STAFF REPORT

PLANNING & ZONING COMMISSION

Wednesday, March 14, 2018

1. PRELIMINARY DEVELOPMENT PLAN REVIEW

IMAGE 1

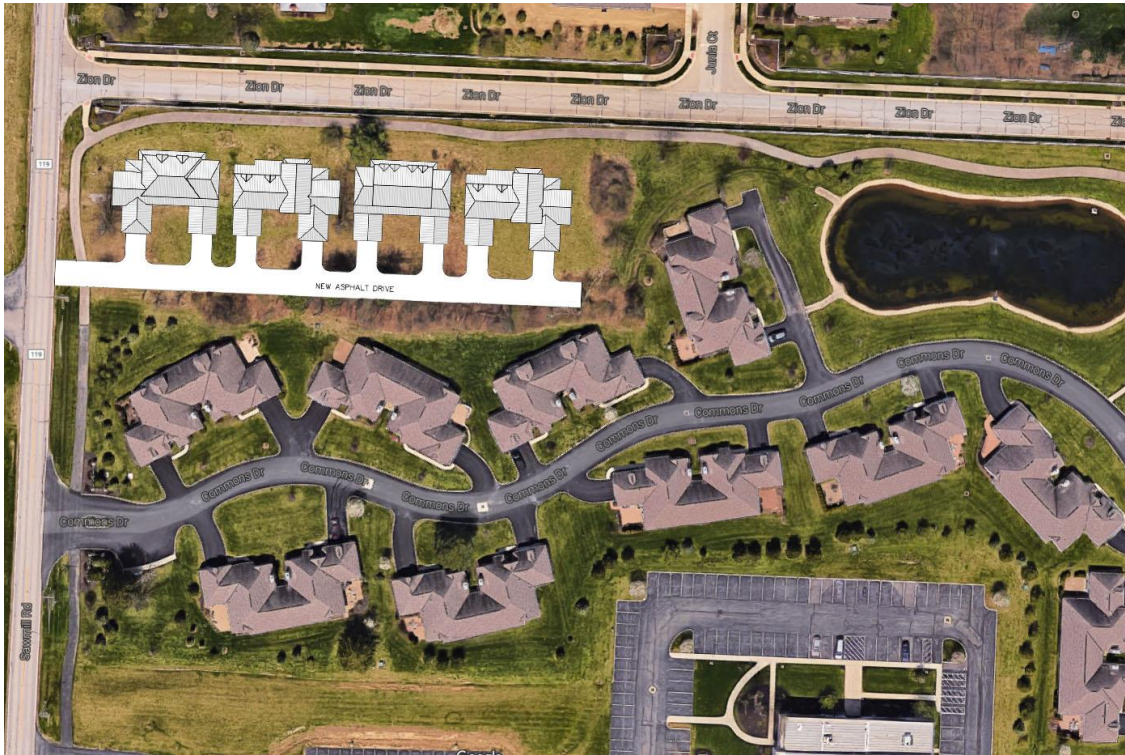
Staff is pleased with the revised site plan, number of units, and elevations presented. Furthermore, staff commends the applicant for following staff's comments and suggestions in order to create a proposal that is much more in line with P&Z's comments.

"Leftover" parcels such as this are often difficult to develop due to their size and location. Typically, they are too small to develop anything reasonable upon and/or their location is sometimes not the best in terms of access. The proposal, however, does a fine job of overcoming each of these hurdles. For one, the site size allows the siting of four units in such a way that they mimic the development to the south (see image 1). Second, the site has adequate access onto Sawmill Road, a road that has adequate capacity for four condominiums.

Other items to consider are the density, scale of buildings, architecture, effect on roadways, and impacts on schools. Overall, the development addresses each of these concerns. One, this new proposal of 5.26 dwelling units per acre (du/ac) is within the densities allowable in the Planned Residence District (PR), which is 9 du/ac. The proposed density of 5.26 du/ac is higher than the 2.98 du/ac of The Commons of Powell to the south. However, a higher density development on a corner parcel is acceptable, and possibly beneficial as a barrier between the road and the less dense existing development. Two, the development is of similar scale to the buildings to the south and as a result, will blend into its surroundings better. Three, the new architecture is of high quality, which helps to be in-line with city's Comprehensive Plan calls for. Furthermore, the fine architecture which is somewhat of a "farm-style" aesthetic would further improve a piece of the city. Lastly, the total 8 units will be geared to empty-nesters and retirees. In turn, they will have little impact of roadways and schools since the users of these type of units have fewer car trips and children than single family homes. As a result, staff does not consider any potential negative traffic impact generated by the proposed development.

Staff recommends the applicant continue to the preliminary development plan review with the following conditions:

1. All Engineering Department comments are addressed before the next submission.
